Statement for the registration for examination of the project NPP Wylfa Newydd/UK

Horizon Nuclear Power is proposing to construct and operate a new nuclear power plant (NPP) at the Wylfa Newydd site in Wales at the coast on the Island of Anglesey. The new NPP shall comprise two UK Advanced Boiling Water Reactors (ABWR). The site already hosts two Magnox NPPs that were shut-down in 2012 and 2015.

Wylfa-1

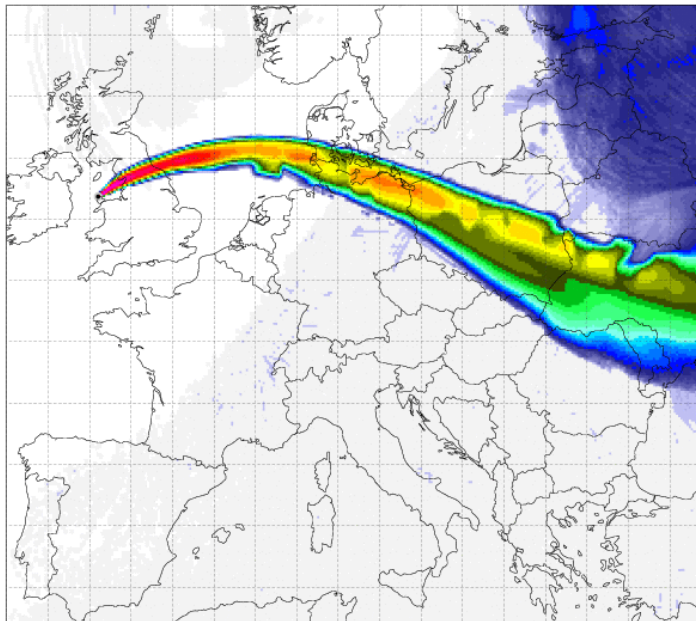
The following figures show weather situations leading to a maximum contamination of Polish territory from the Wylfa site.

Parts of the Polish territory could be contaminated with about 100 kBq Cs-137/m², small parts even higher (between the orange and the light red scale). This is more than the contamination after Chernobyl when the average contamination¹⁵ was below 10 kBq/m².

In case of a severe accident in Wylfa with a containment failure, whole of Europe could be contaminated severely.

Request: Any new NPP in UK needs to prove that a severe accident with a containment failure is not possible!
